**PEER 19 - Environmental Evaluation Group  
Review Reports**

**REPORT NUMBER EEG-3**

**RADIOLOGICAL HEALTH REVIEW  
OF THE DRAFT ENVIRONMENTAL IMPACT STATEMENT  
(DOE/EIS-0026-D) WASTE ISOLATION PILOT PLANT,  
U. S. DEPARTMENT OF ENERGY**

**August 1979**

Figure 1

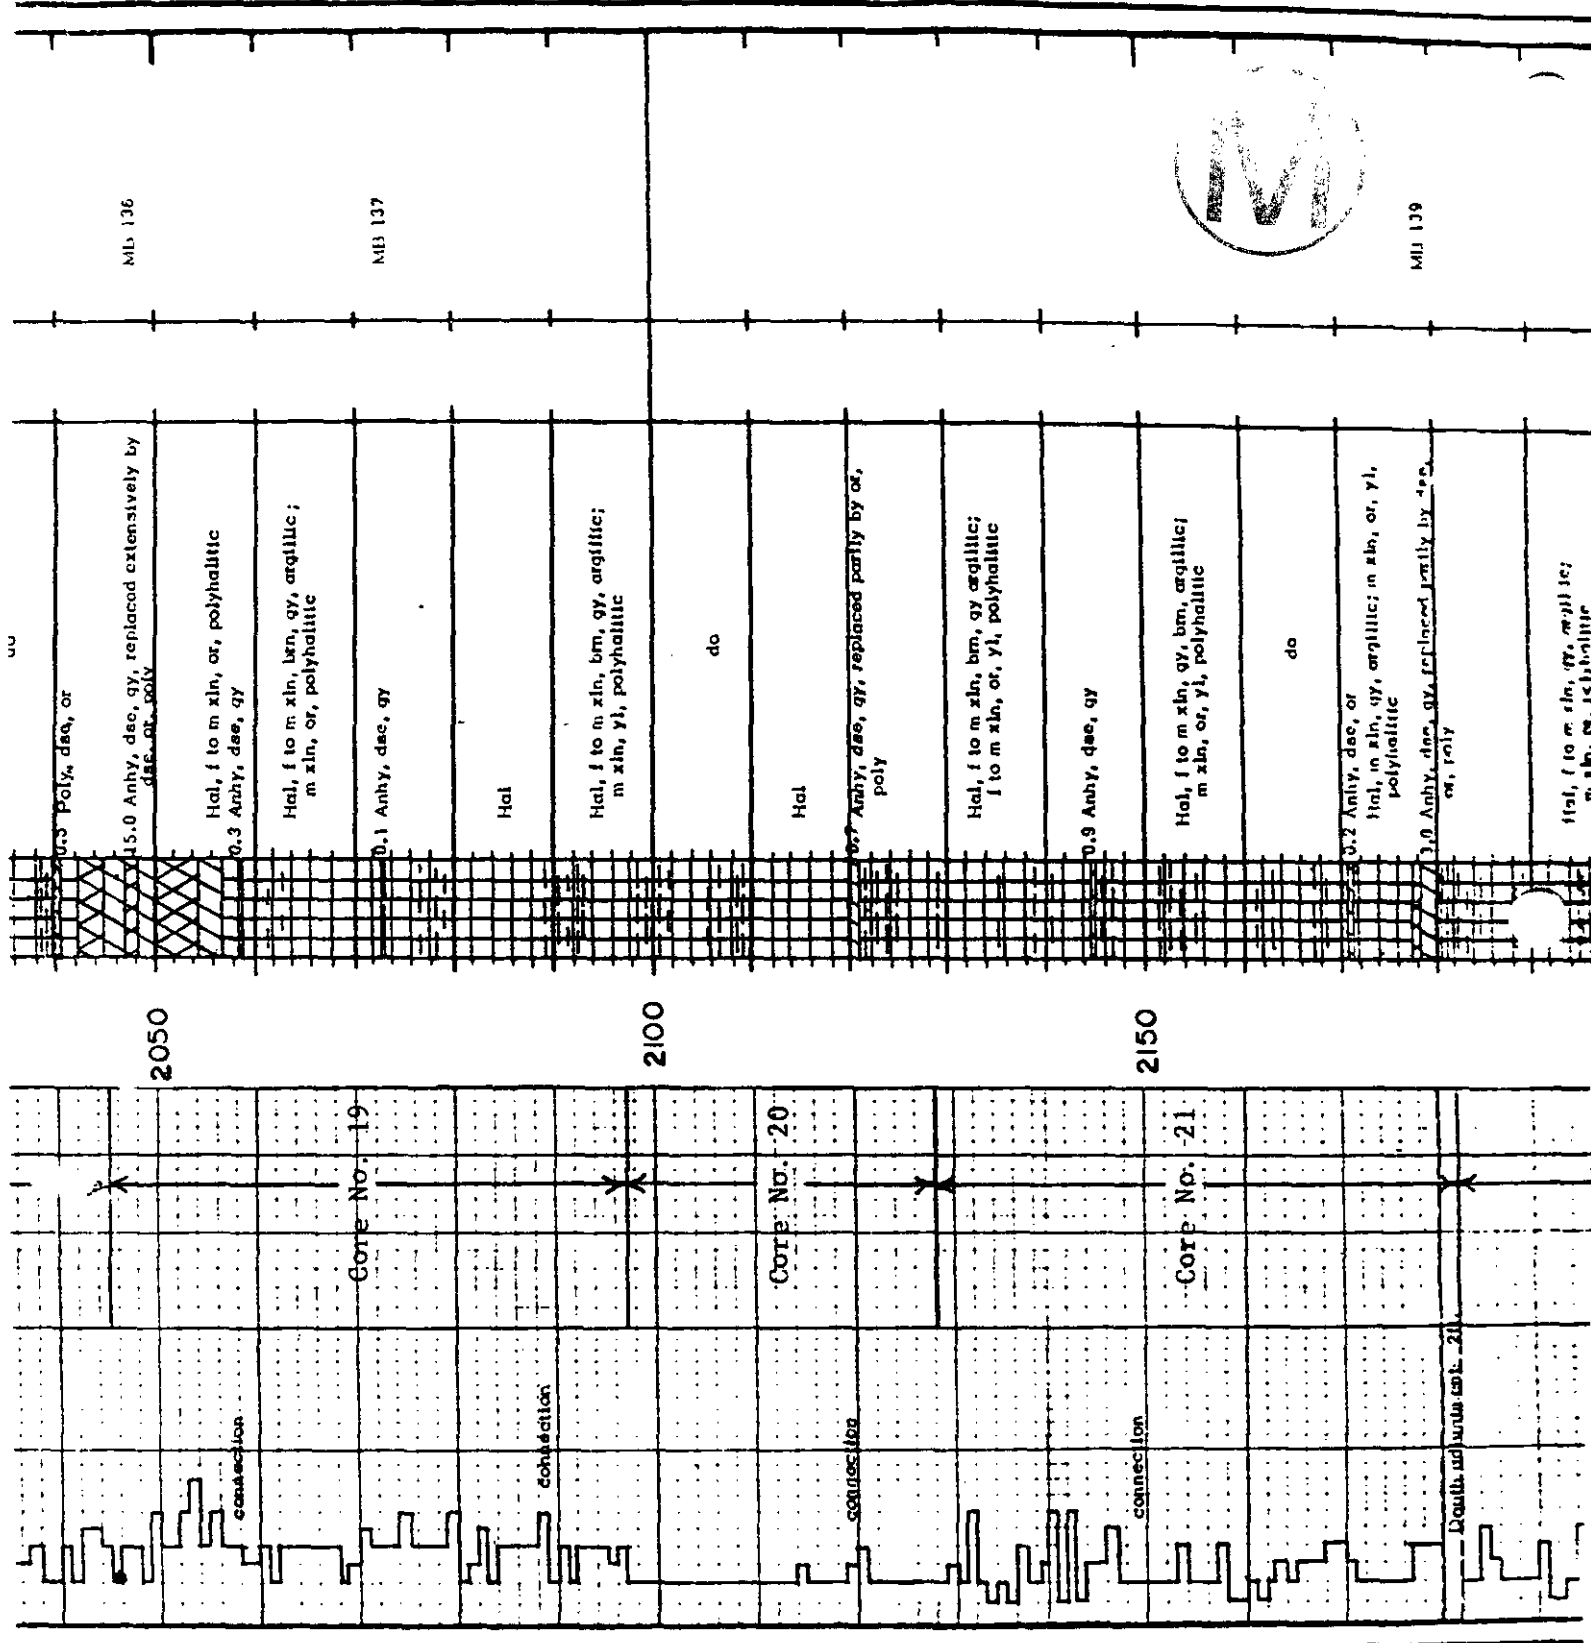
- 4) The lithology of the repository horizons is described on page 7-24 of the DEIS and parts of the lithologic log of the ERDA-9 hole are shown in Figures 1 and 2 of this section (from Fig. 4.3-3B of the GCR). These sections of the logs describe the lithology of the repository horizons for CH and RH zones as shown on Figure 4.3-3A of the GCR. The logs show the presence of clay, anhydrite and polyhalite in addition to halite, as the constituents of both repository horizons. The presence of these impurities should be taken into account in evaluating physical, hydrological, thermal and strength characteristics of "rock salt" from the repository horizons.

Figure 1

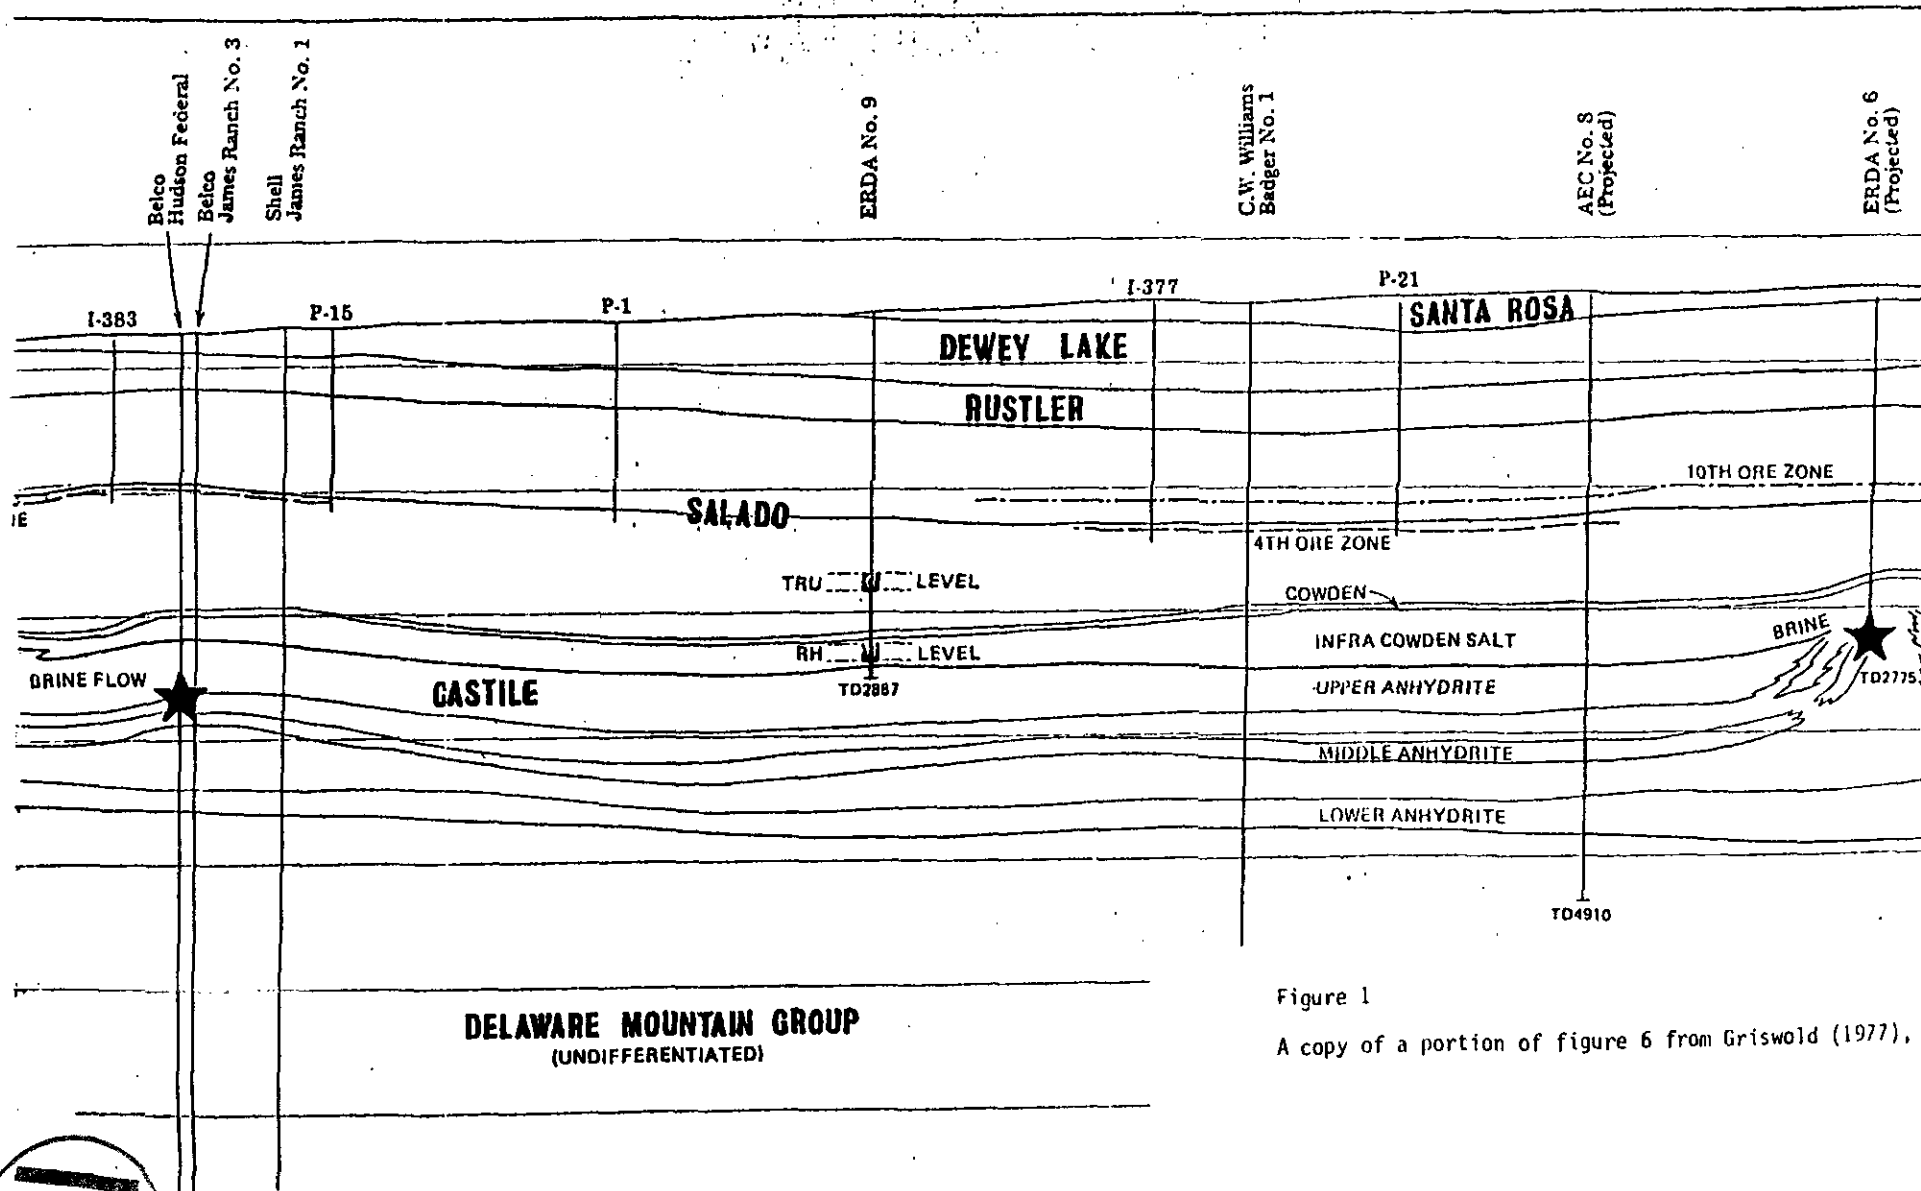
Capitan reef. Griswold's Figure 6 (see Figure 1) graphically demonstrated the stratigraphic position of these brine flows in relationship to the proposed repository.

Figure 2  
 Potentiometric  
 Surface of Delaware  
 Mountain Group Aquifer  
 Note lack of observations  
 in the crosshatched area.  
 (from Fig. 6.3-1)

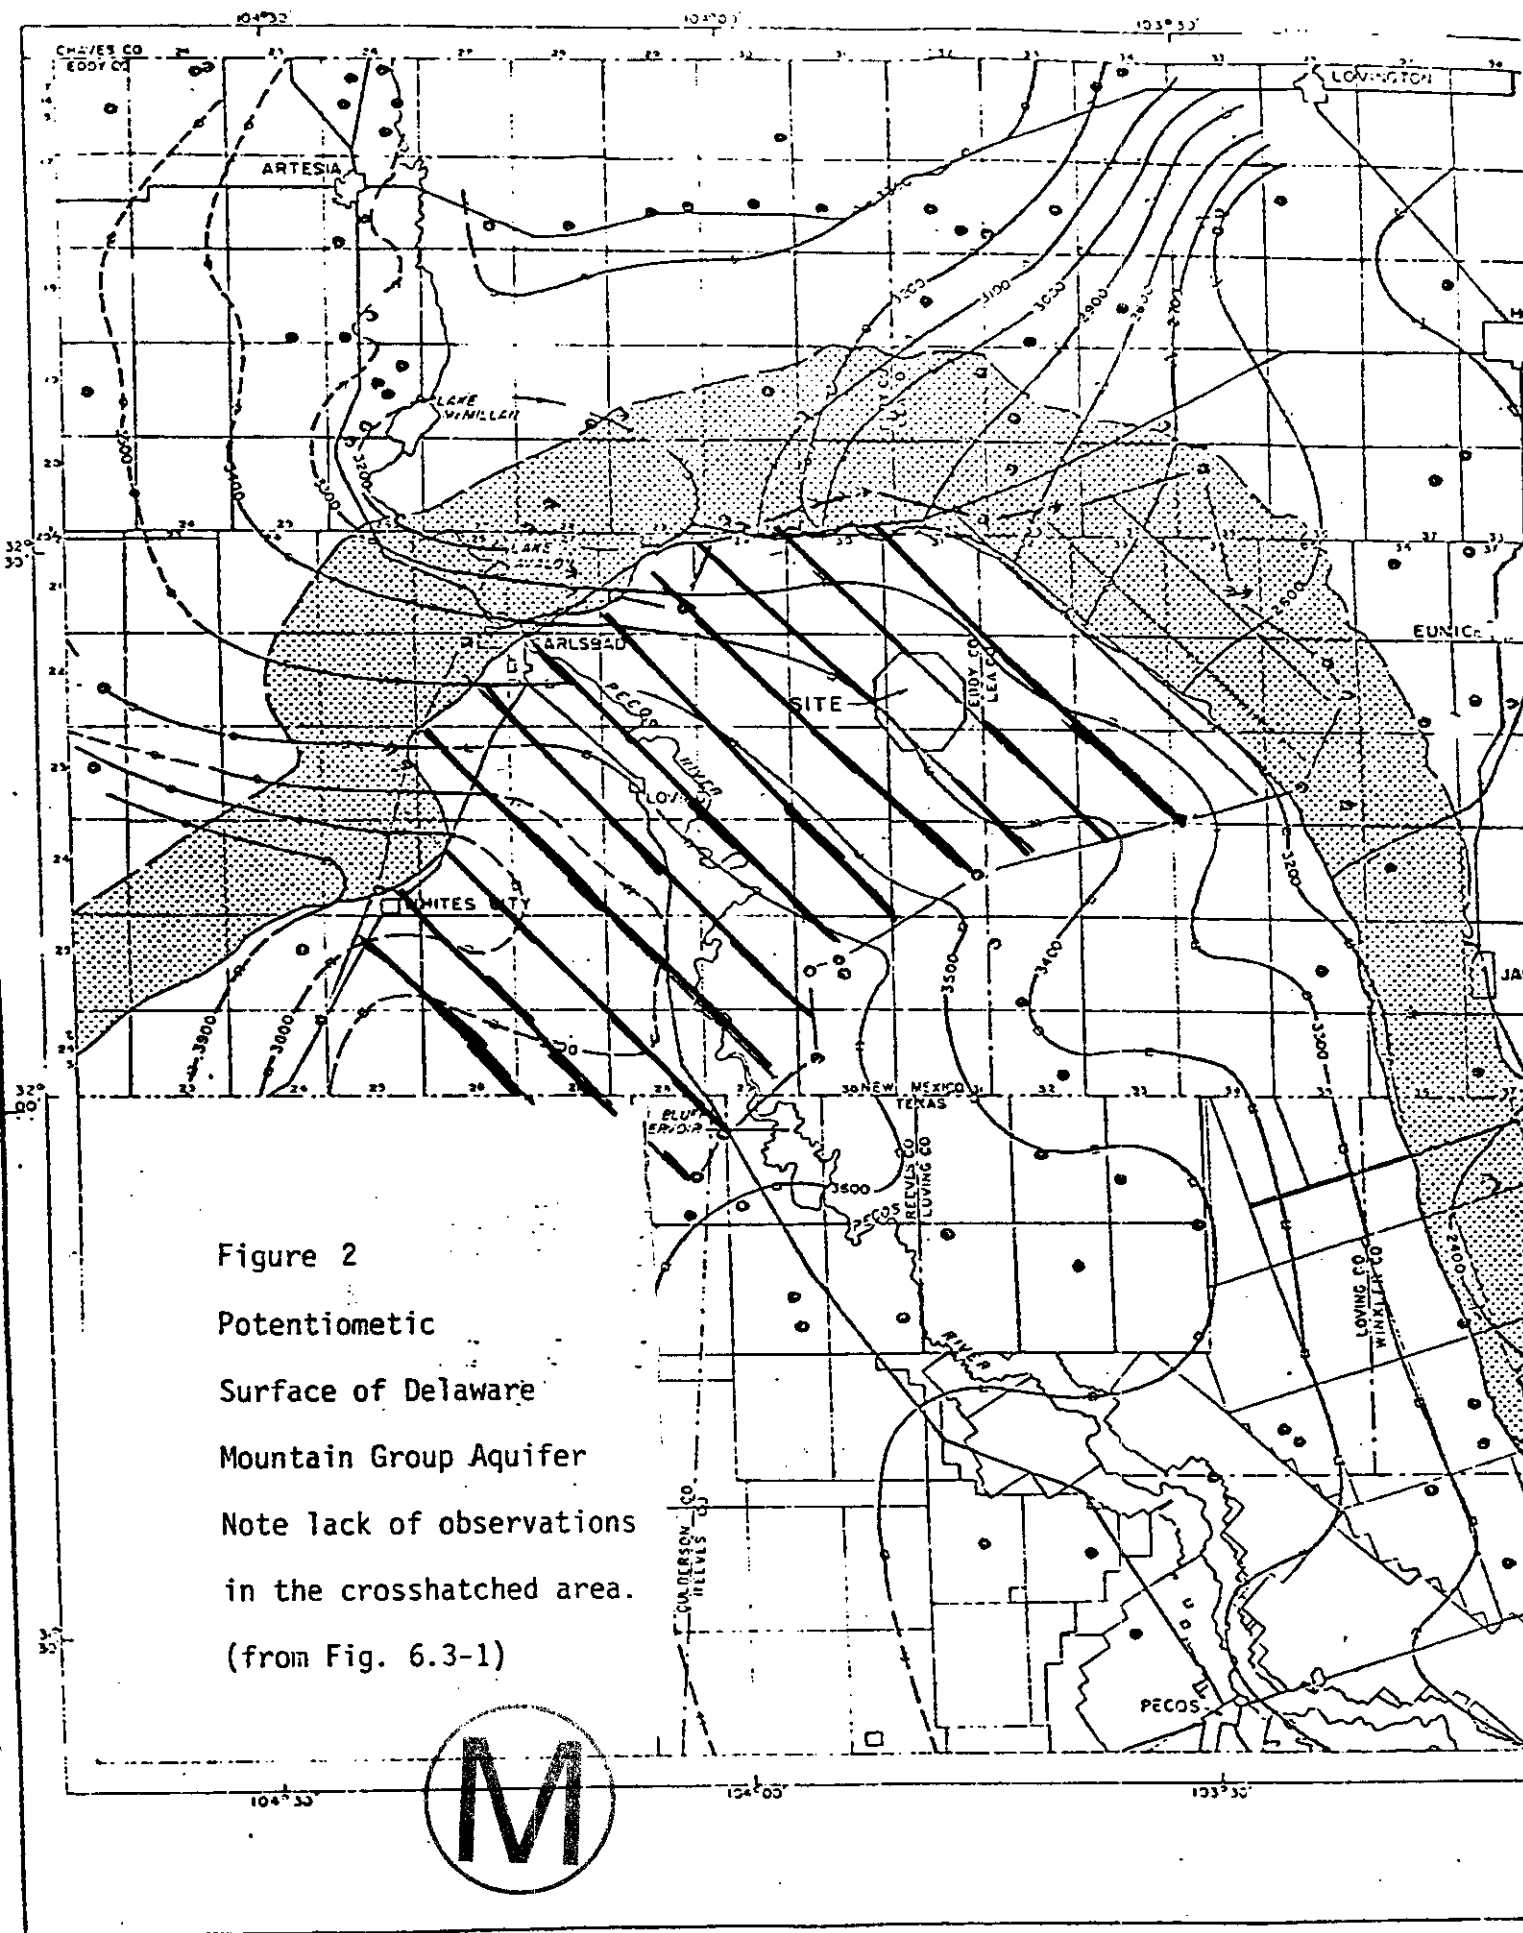
The underlying aquifer (Delaware Mountain Group) is discussed on (6-14); the potentiometric map for this aquifer (Fig. 6.3-1) is based on Hiss (1975). As shown in Figure 3, there is a large area around the site in which no well data were available. Are there additional data which could be included in
